EAGLE MOUNTAIN PLANNING COMMISSION MEETING

March 23, 2021, 5:30 PM

TITLE:	Stonebridge Montessori (Concept Plan)
ITEM TYPE:	Concept Plan
APPLICANT:	Jon Jensen

TITLE:	PUBLIC HEARING - Macey's at Market Place (Site Plan)
ITEM TYPE:	Site Plan
APPLICANT:	Jared Mitchell (Associated Food Stores)

ELECTRICAL SITE
PLAN -
PHOTOMETRIC

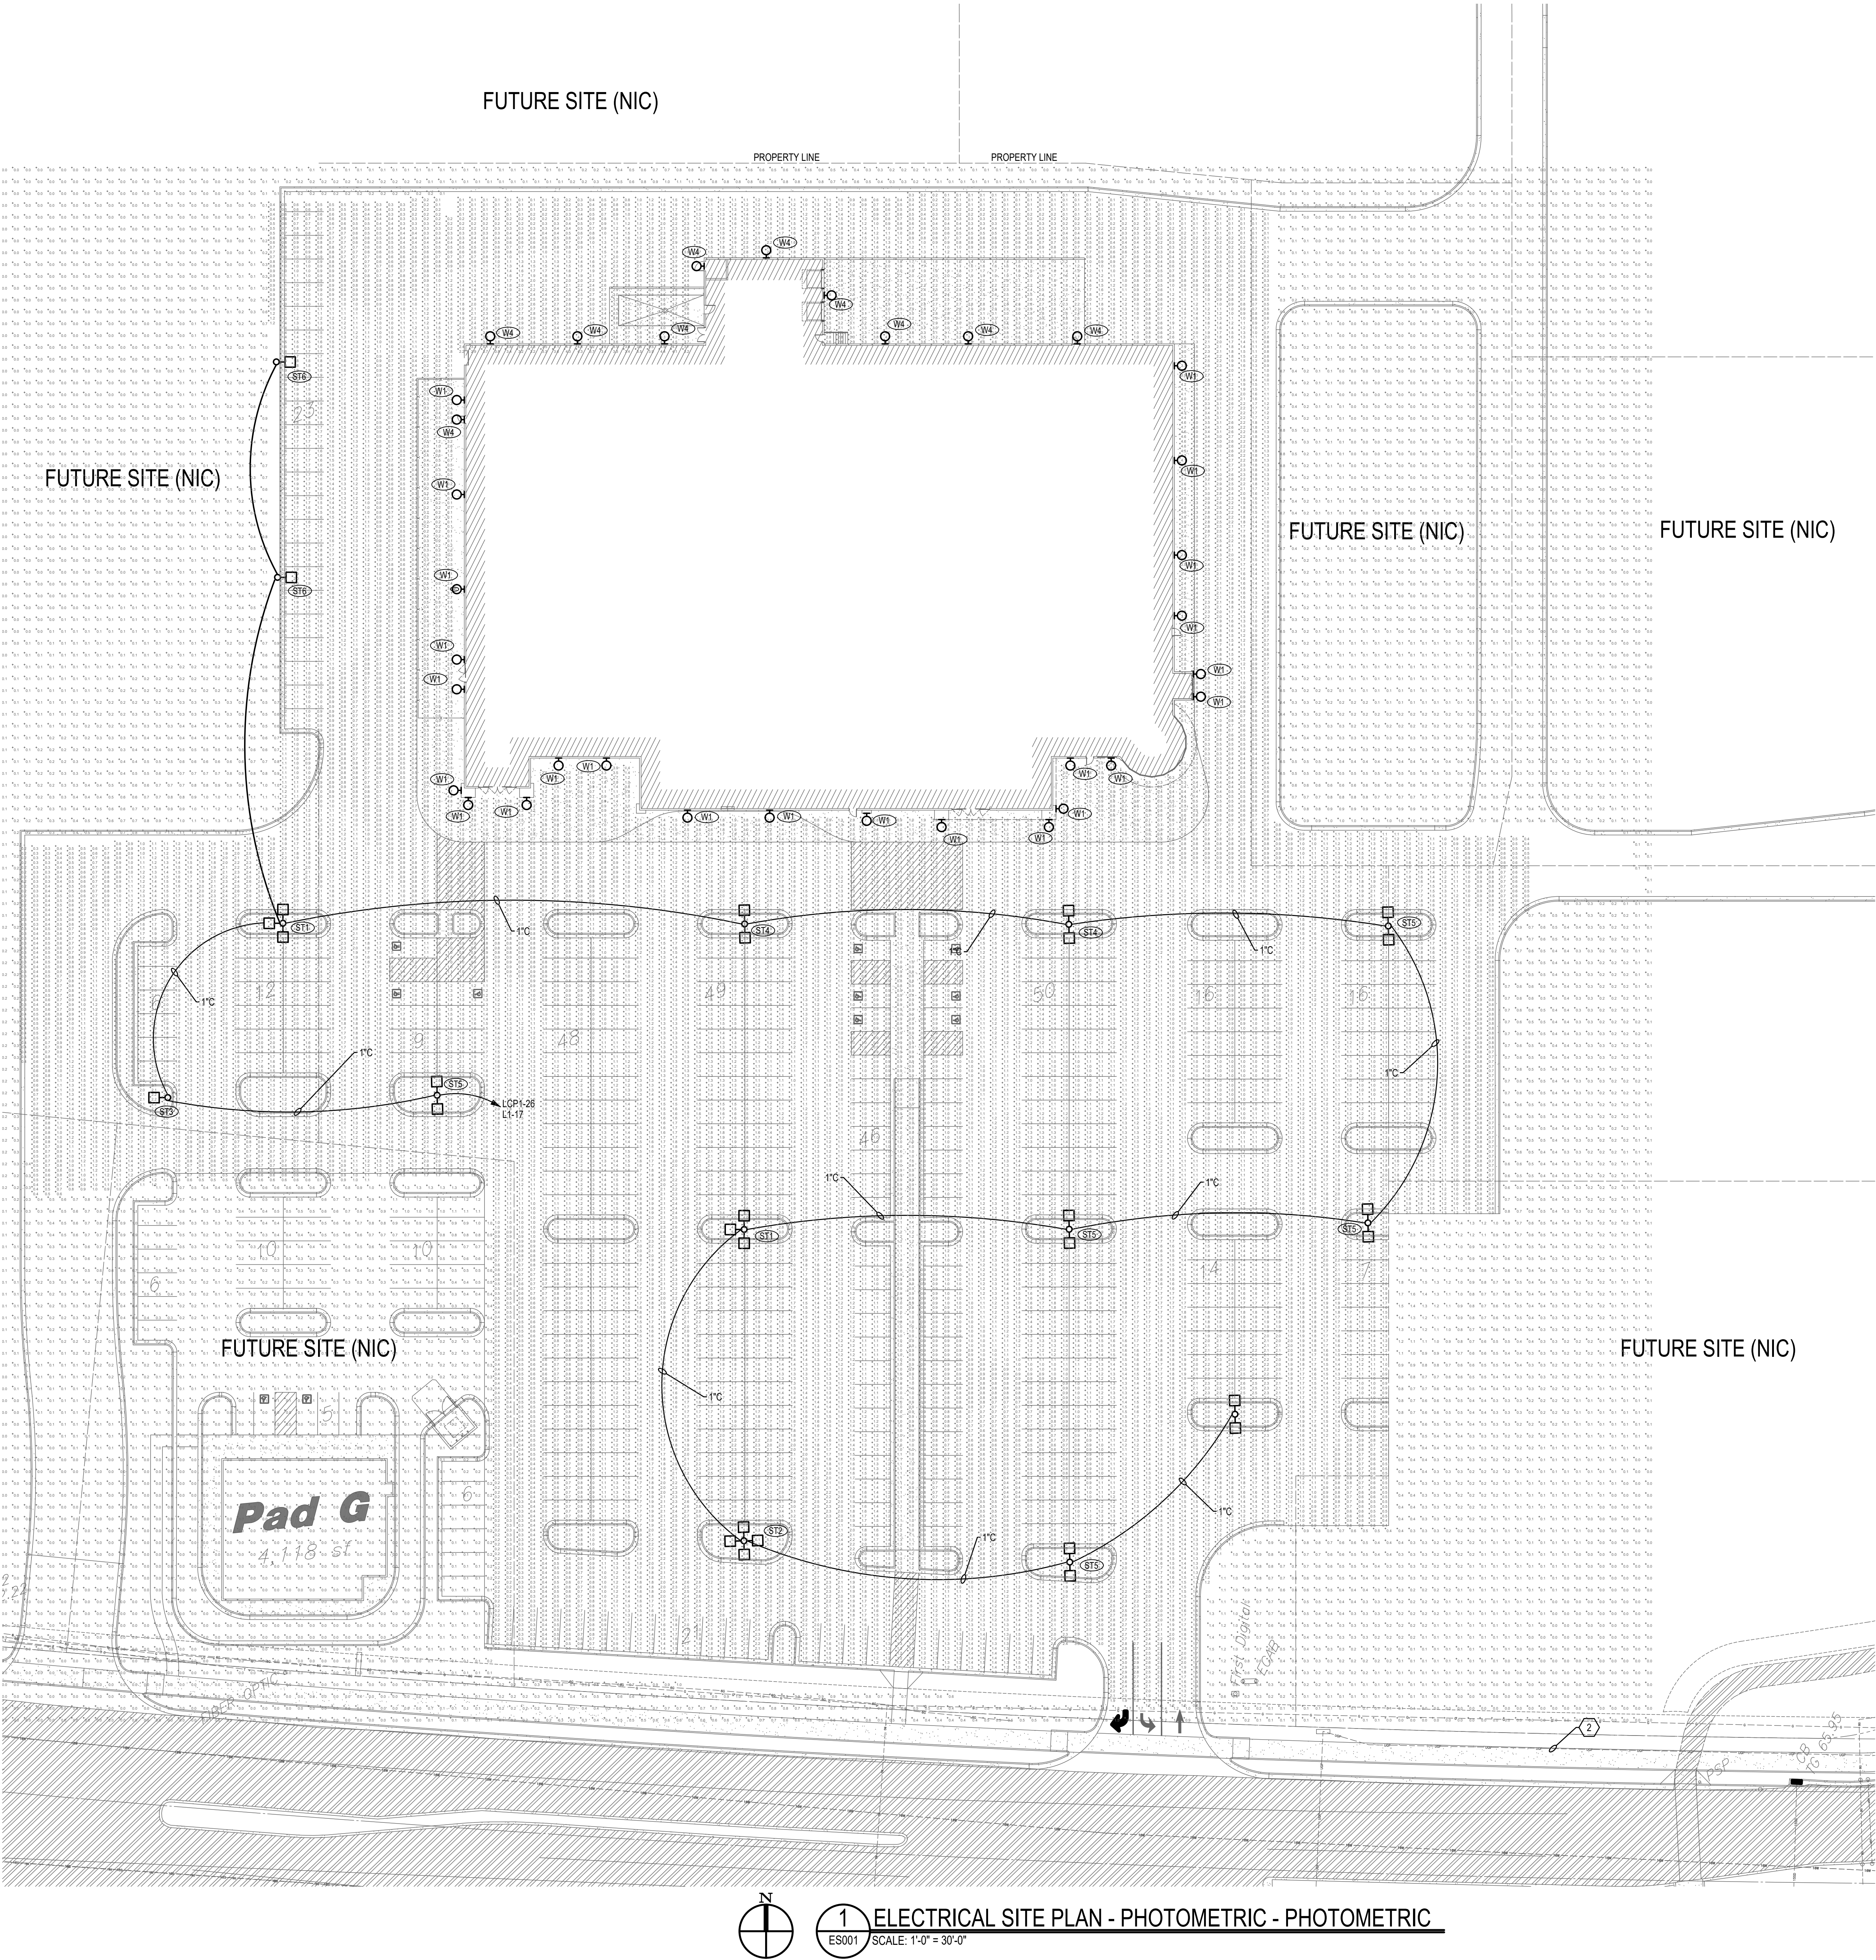
- **17.100.060 C** requires building lighting to be fully shielded and directed downward so that the light source is not visible from beyond the property where the structure is located, and that lighting complies with dark sky standards in 17.56. All proposed lighting is full cut-off and dark sky compliant. The proposal is for 70,356 lumens per acre, this is well under the maximum of 100,000 lumens per acre. While there is some light trespass off the lot, it goes onto adjacent commercial lots in the same Master Site Plan. Staff feels this is acceptable to maintain uniformity in parking lot lighting. It is the opinion of staff that the proposal **complies** with 17.100.060 C.
